Amendments to the Drawings:

REMARKS

FIGURE 1
(PREFERRED)

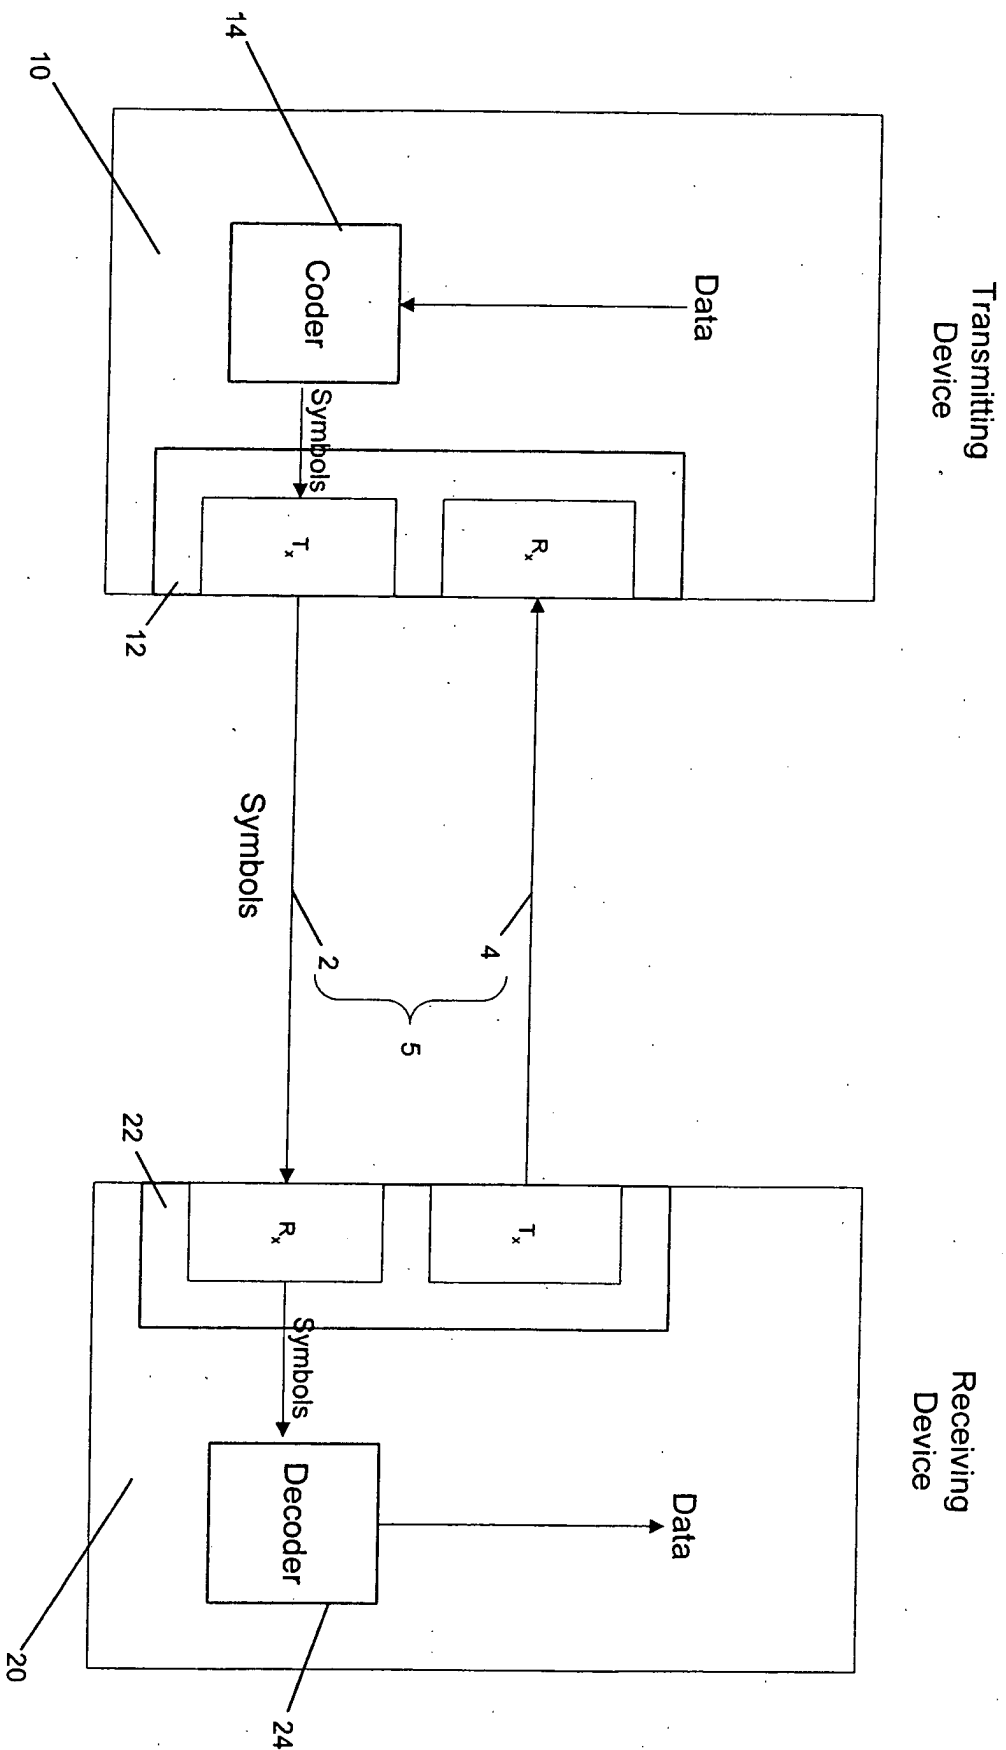
Drawing Figures 1-2 are amended herewith in accordance with the Examiner's requirements to label object 148 as "channel" and to add the legend "Prior Art" to Figure 1.

In response to the Examiner's drawing objections in section 2 of the current Office Action, Replacement Drawing Sheet 1 adds the legend --Prior Art-- to Figure 1, and Replacement Drawing Sheet 2 adds the legend --Channel-- to the block referenced 148. In addition, in block 150 the spelling of modulator has been corrected. The changes are indicated in red on the attached annotated copies.
